**UPGRADE BULLETIN: 200701REV**

Fleetwood Brand:  
Discovery  
Discovery LXE  
Pace Arrow LXE

Holiday Rambler Brand:  
Endeavor  
Navigator

Sealing the front driver's side compartment to avoid water intrusion

**Figure 1**

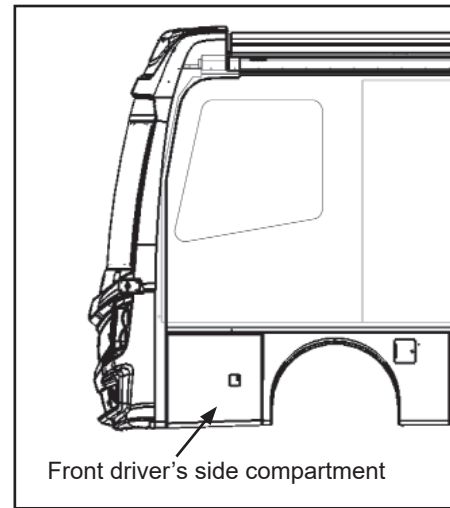
2. Locate the front driver's side exterior compartment. Refer to Figures 1 and 2.

**Figure 2**

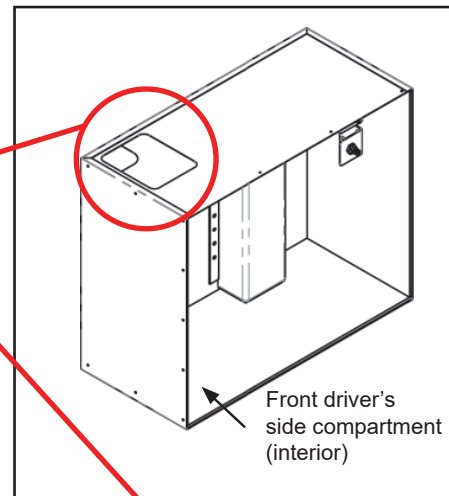
5. Apply black Sikaflex 221 (polyurethane adhesive/sealant) along the exterior corner edges of the compartment. See Figures 2 and 3.

**Note: The circled area may also need thoroughly inspected and an application of foam sealant.**

**Figure 3**

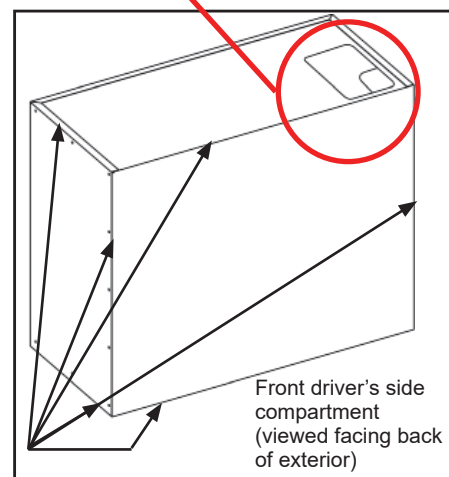
Seal seams where indicated by arrows
